TVA-BFN-TS-441R1

BROWNS FERRY NUCLEAR PLANT (BFN) - UNITS 2 and 3 - TECHNICAL SPECIFICATIONS (TS) CHANGE TS-441 REVISION 1 - UPDATE OF PRESSURE-TEMPERATURE (P-T) CURVES

PROPOSED TECHNICAL SPECIFICATIONS (TS) CHANGE TS-441R1 TVA EVALUATION OF PROPOSED CHANGE

**Figure 3.4.9-1
Pressure/Temperature Limits**

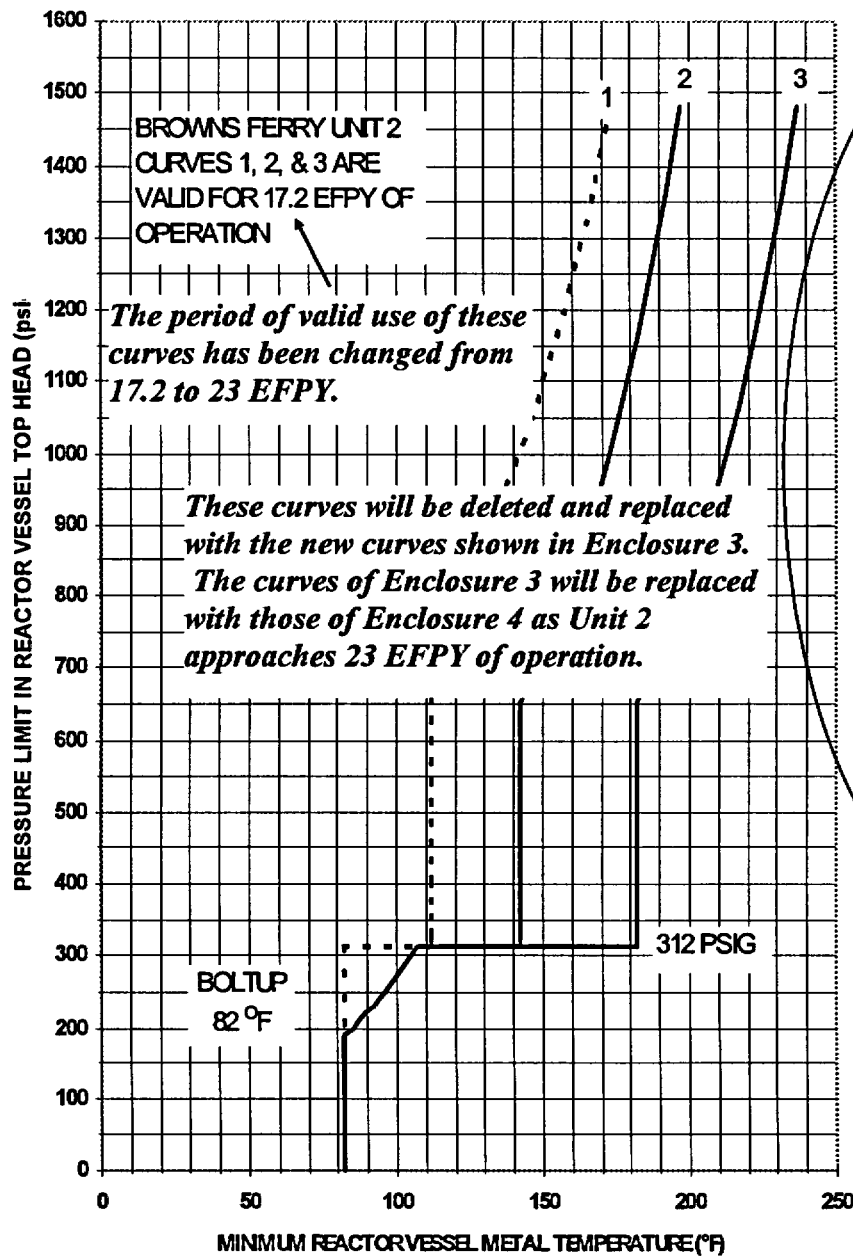
Curve Legends have been revised on new TS pages to include the additional curves, their applicability, and the new Unit 2 valid EFPY interval of 23 years

Figure 3.4.9-1
Pressure/Temperature Limits

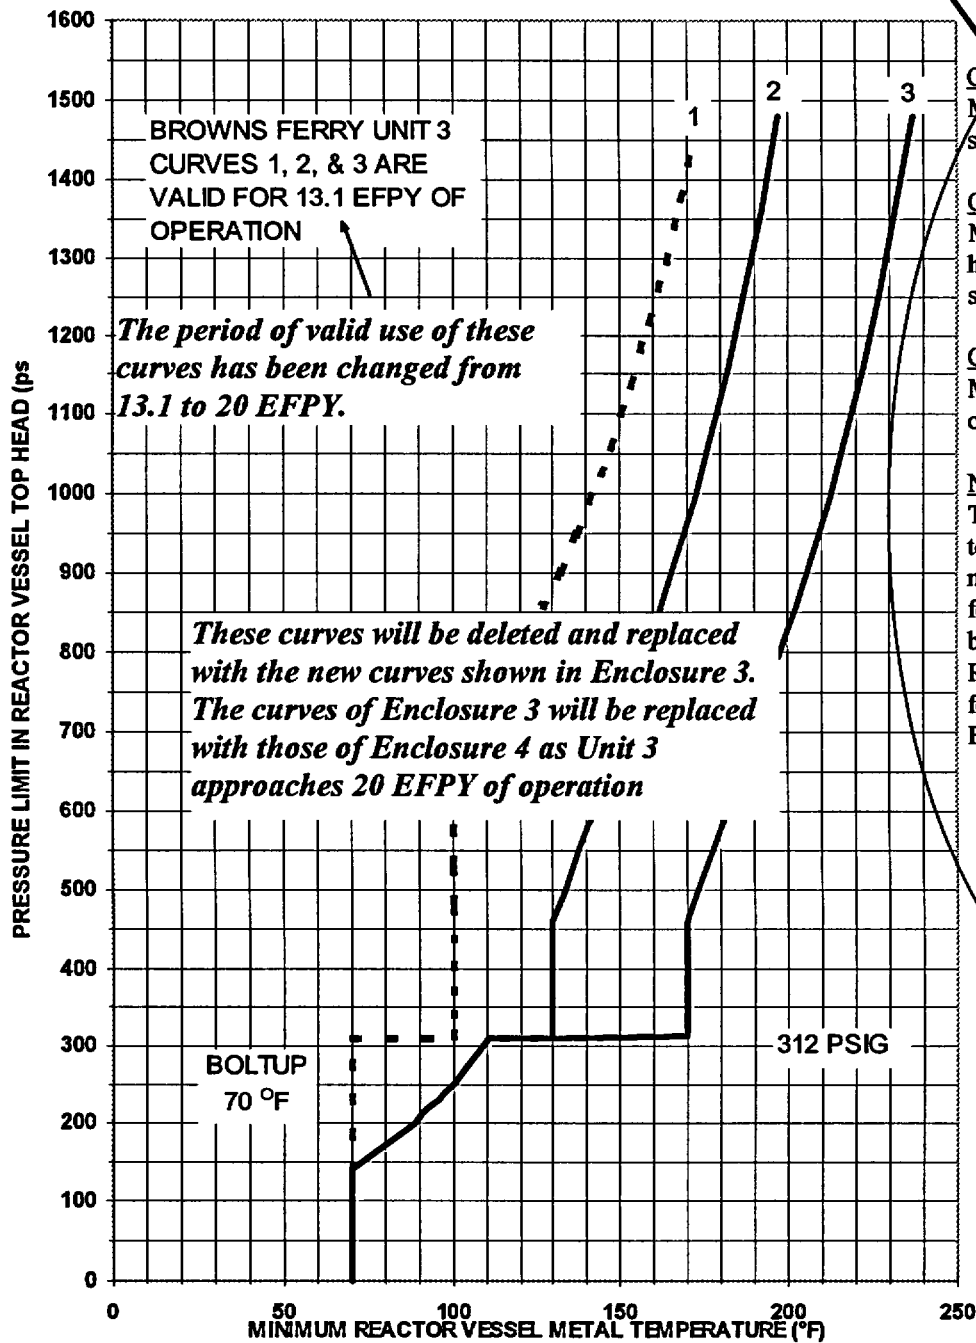
Curve Legends have been revised on new TS pages to include the additional curves, their applicability, and the new Unit 3 valid EFPY interval of 20 years

Figure 3.4.9-1
Pressure/Temperature Limits for
Mechanical Heatup, Cooldown following Shutdown, and
Reactor Critical Operations

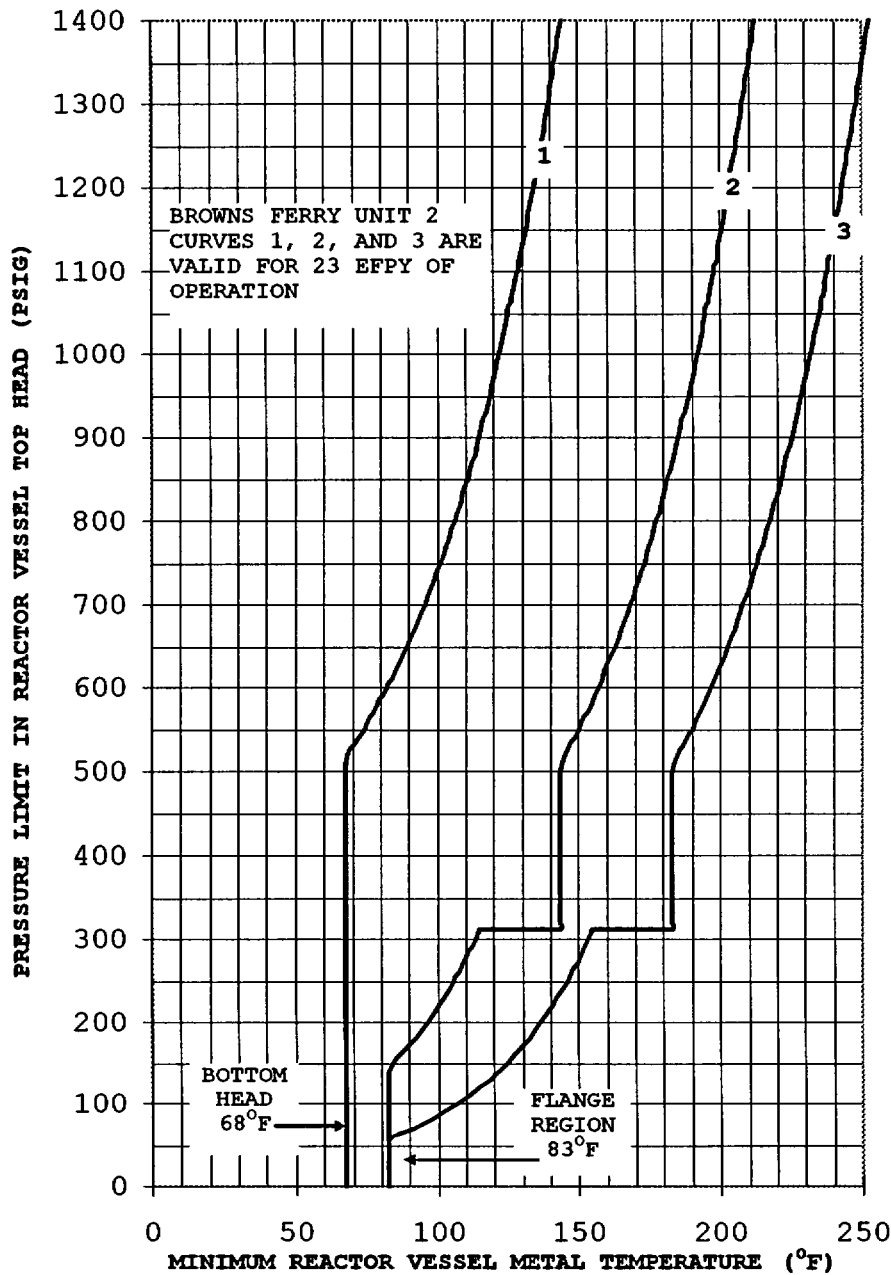
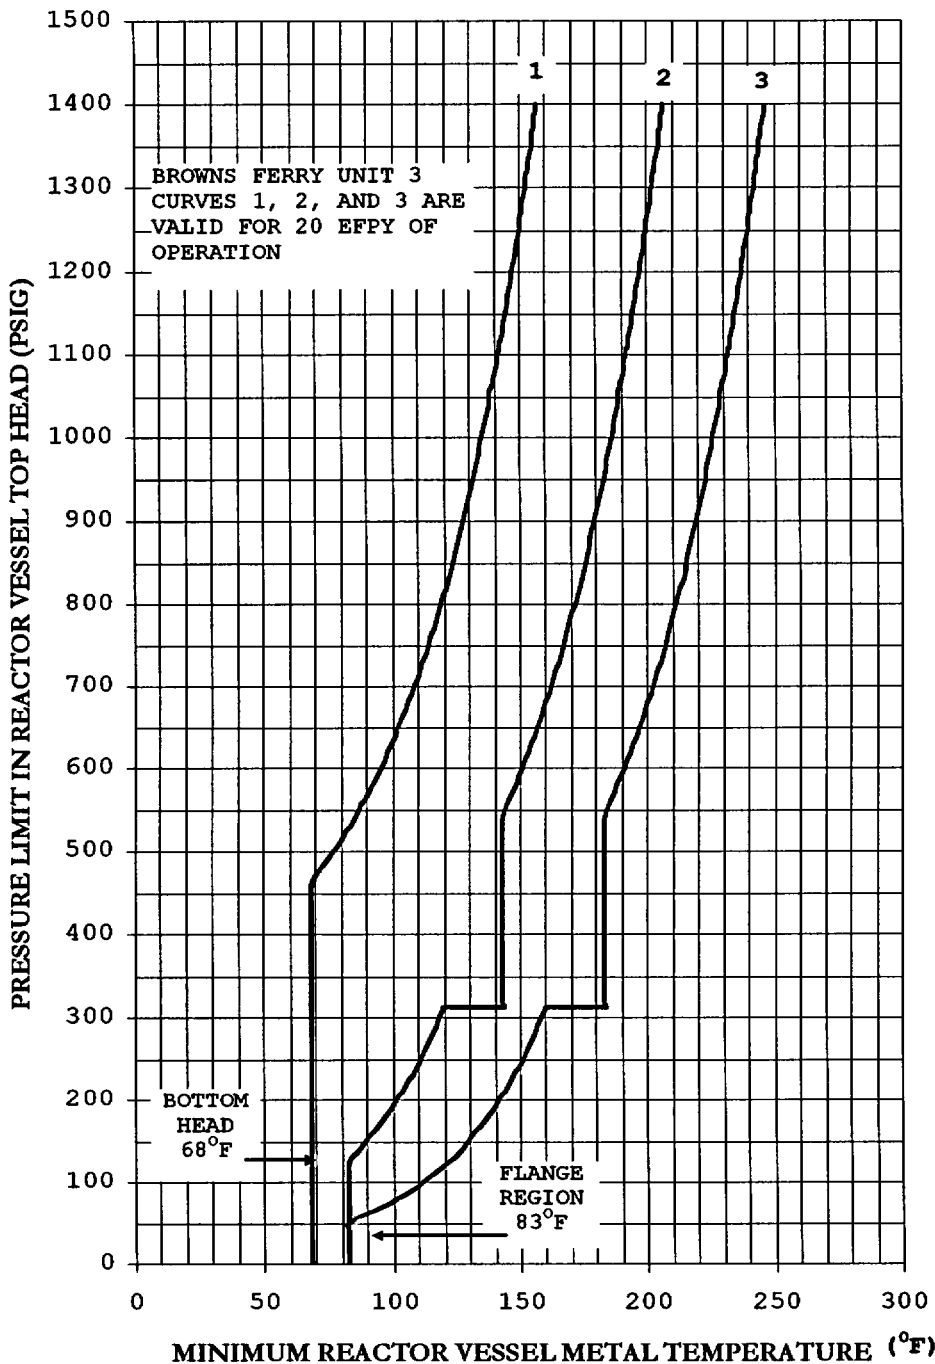
1. TS Figure 3.4.9-1 for Unit 2 and Unit 3 is deleted and replaced in its entirety.

2. The new TS Figure 3.4.9-1 contains an added curve which specifically details reactor vessel bottom head temperature versus pressure limitations for non-critical heatup/cooldown operational conditions.
3. A new TS Figure 3.4.9-2 has been added which contains curves for the reactor vessel bottom head and the upper vessel/beltline regions for in-service leak and hydrostatic testing activities.
4. The legend information on these TS figures has been revised to appropriately describe the additional curves and their usage.
5. References to these figures within the TS body have been revised as necessary to appropriately reflect their use.

Curve No. 1
Minimum temperature for
bottom head during
mechanical heatup or
cooldown following nuclear
shutdown.

Curve No. 2
Minimum temperature for
upper RPV and beltline
during mechanical heatup
or cooldown following
nuclear shutdown.

Curve No. 3
Minimum temperature for
core operation
(criticality).

Notes
These curves include
sufficient margin to
provide protection against
feedwater nozzle
degradation. The curves
allow for shifts in RT_{NDT}
of the Reactor vessel
beltline materials, in
accordance with Reg. Guide
1.99, Rev. 2, to
compensate for radiation
embrittlement for 23 EFPY.

Figure 3.4.9-2
Pressure/Temperature Limits for
Reactor In-Service Leak and Hydrostatic Testing

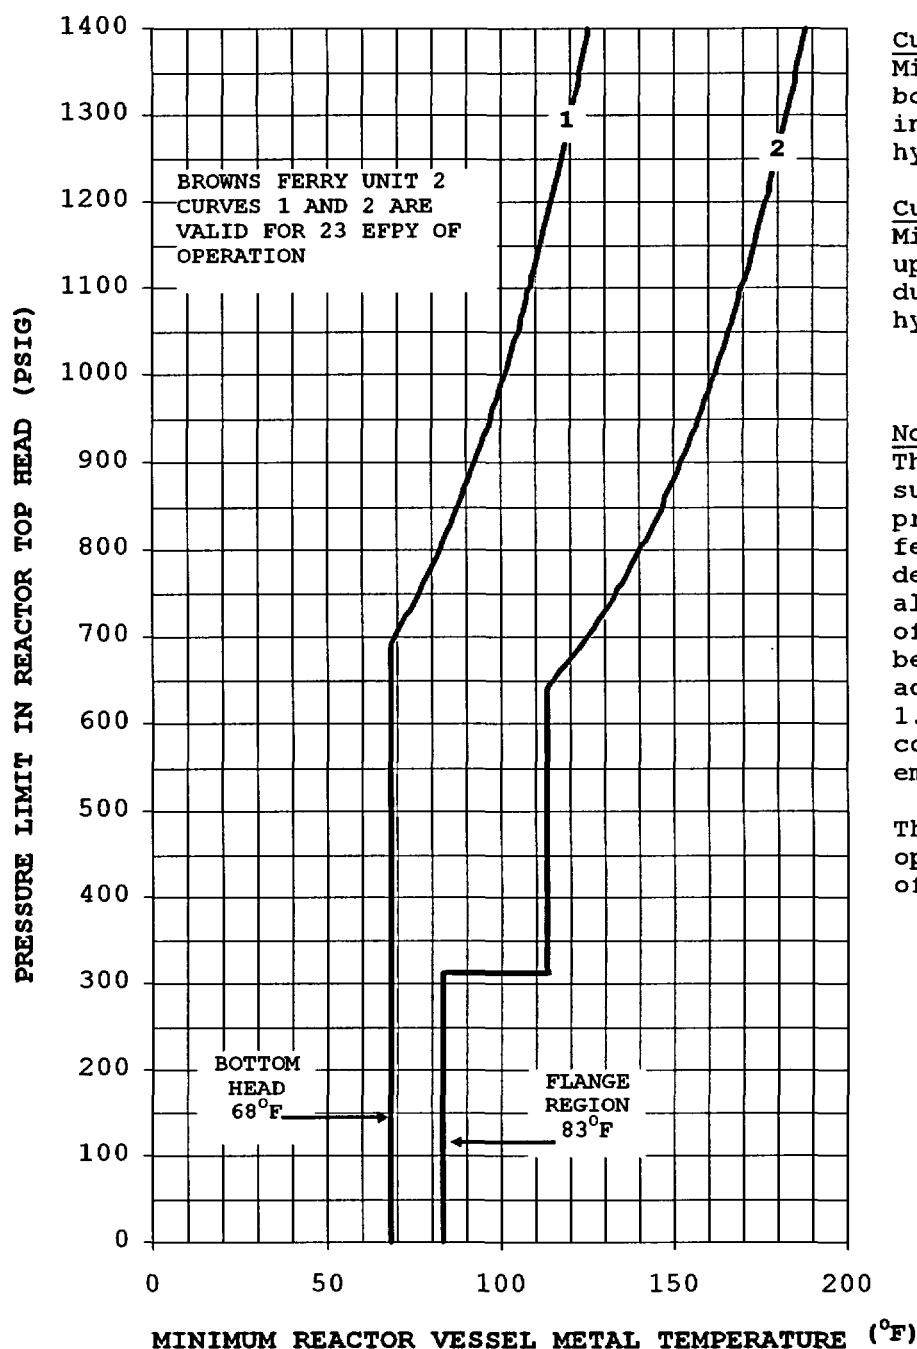
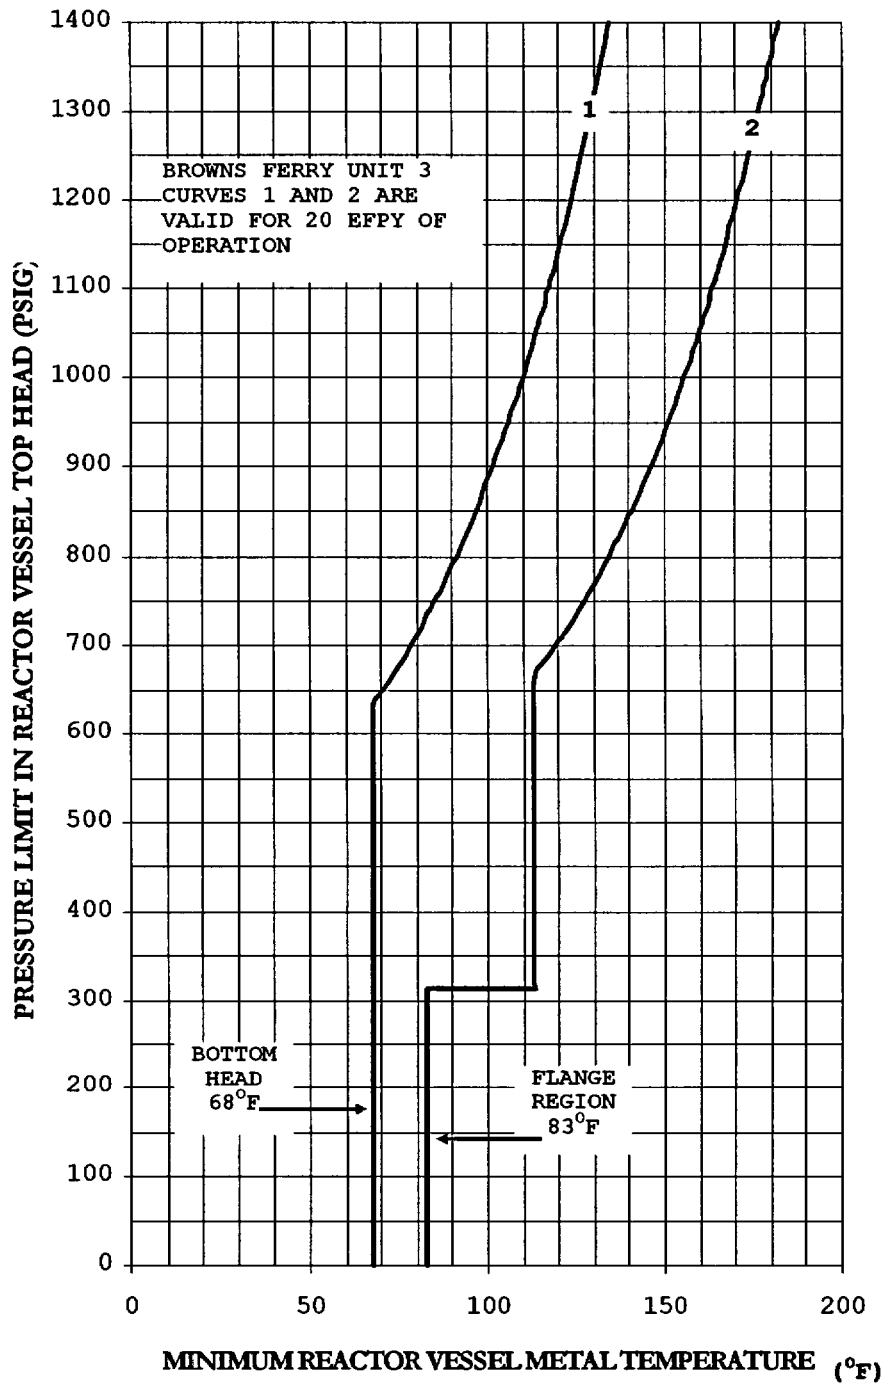
- A fourth curve which specifies the temperature limits for the reactor vessel bottom head region during in-service and hydrostatic testing of the reactor vessel. The minimum temperature for the bottom head during this testing is established by this P-T curve.
- A fifth curve which specifies the temperature limits on the reactor vessel bottom head during startup and shutdown operations when the reactor is not critical.

Figure 3.4.9-1
Pressure/Temperature Limits for Mechanical Heatup, Cooldown following Shutdown, and Reactor Critical Operations

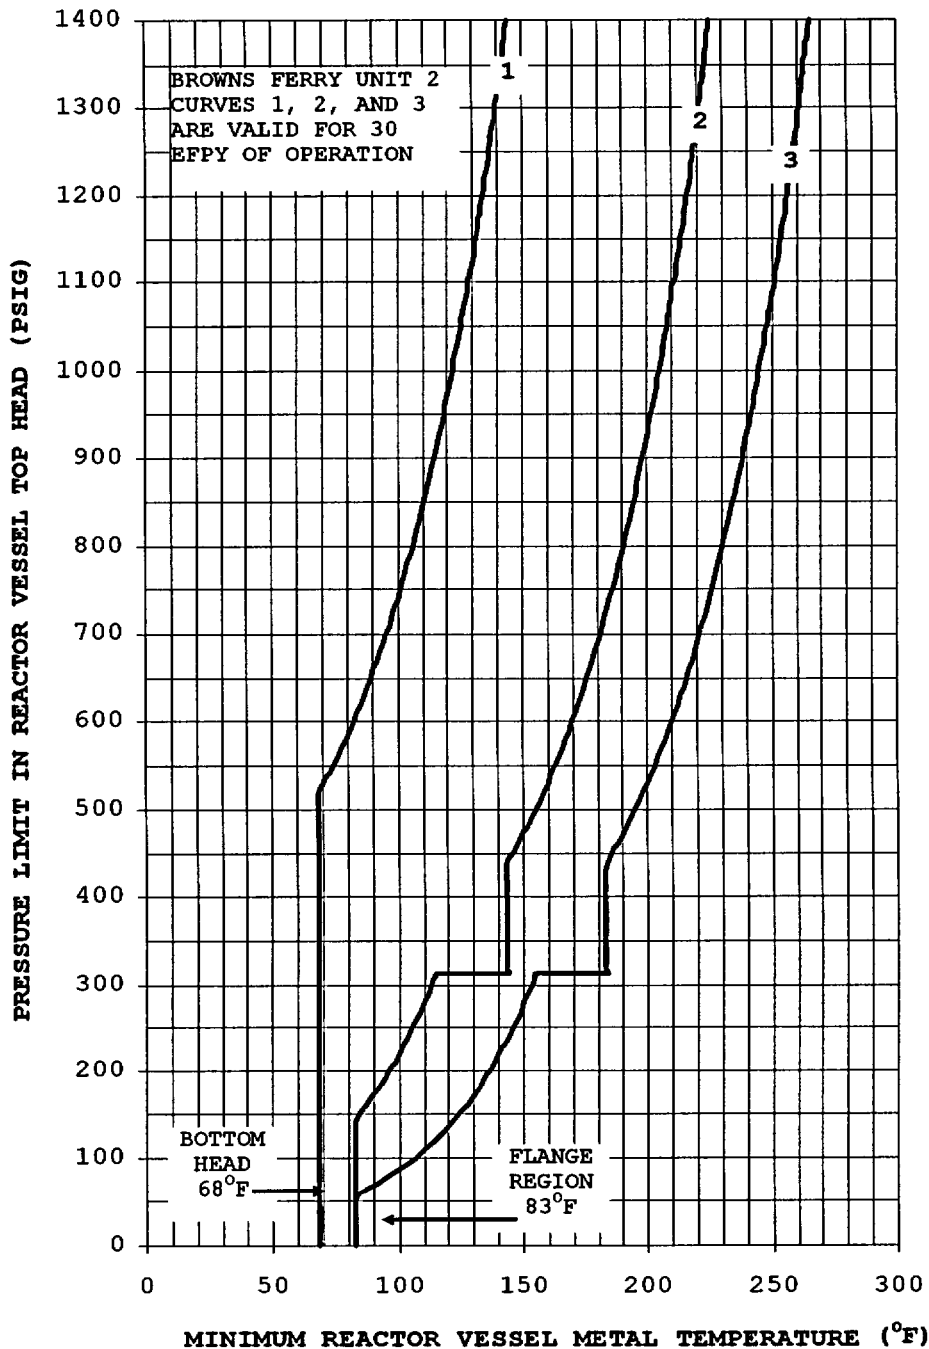
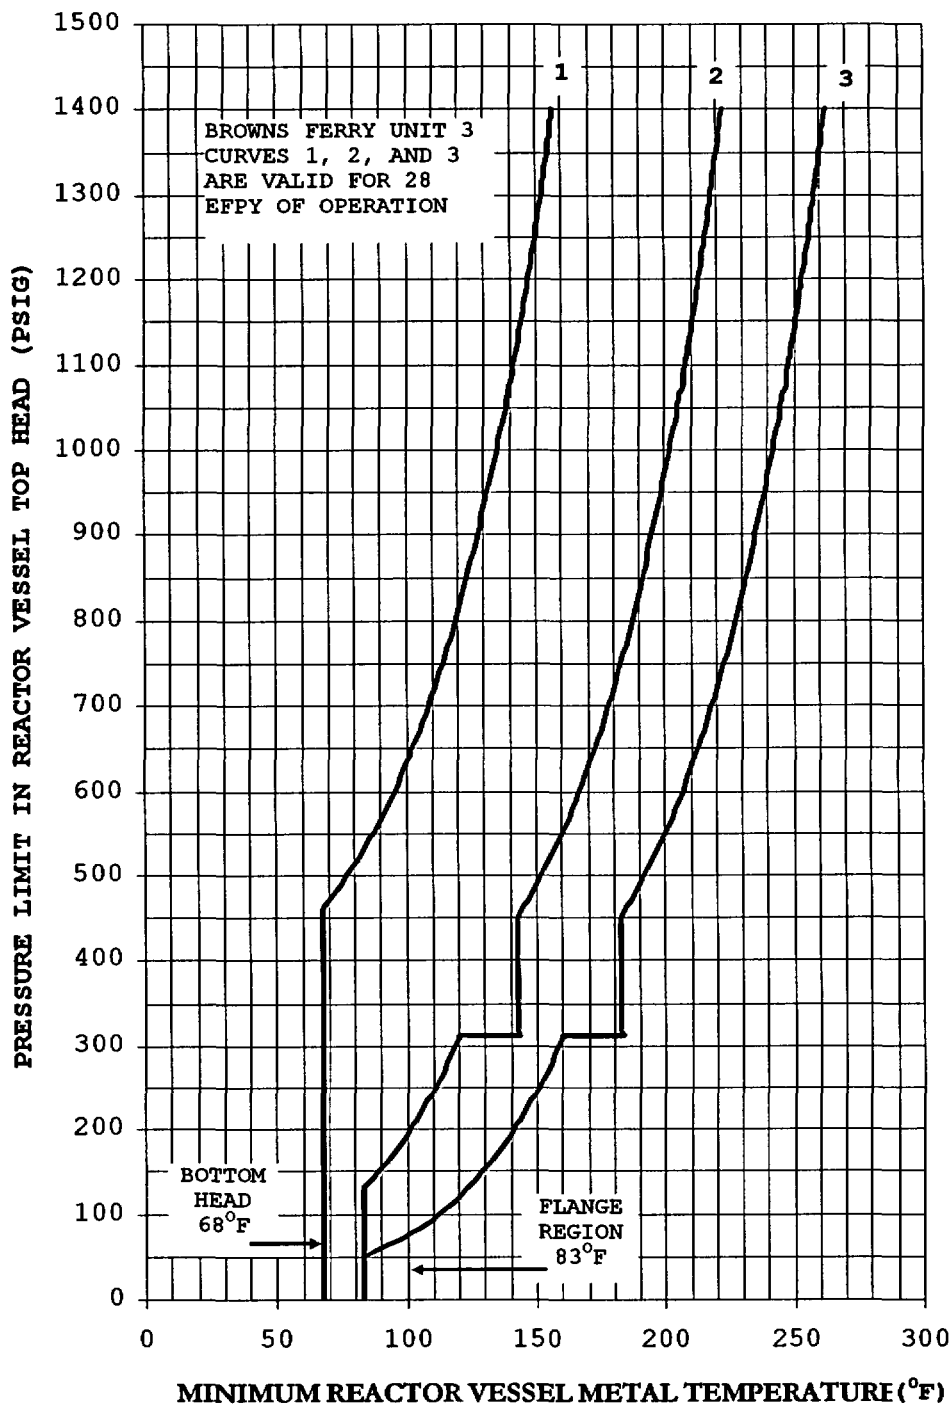
These pages are submitted for NRC review and approval, however, they will not be placed into the BFN TS at this time. As Unit 2 approaches 23 EFPY, and as Unit 3 approaches 20 EFPY, TVA will replace the TS figures shown in Enclosure 3 above with these figures.

Curve No. 1
Minimum temperature for bottom head during mechanical heatup or cooldown following nuclear shutdown.

Curve No. 2
Minimum temperature for upper RPV and beltline during mechanical heatup or cooldown following nuclear shutdown.

Curve No. 3
Minimum temperature for core operation (criticality).

Notes
These curves include sufficient margin to provide protection against feedwater nozzle degradation. The curves allow for shifts in RT_{NDT} of the Reactor vessel beltline materials, in accordance with Reg. Guide 1.99, Rev. 2, to compensate for radiation embrittlement for 30 EFPY.
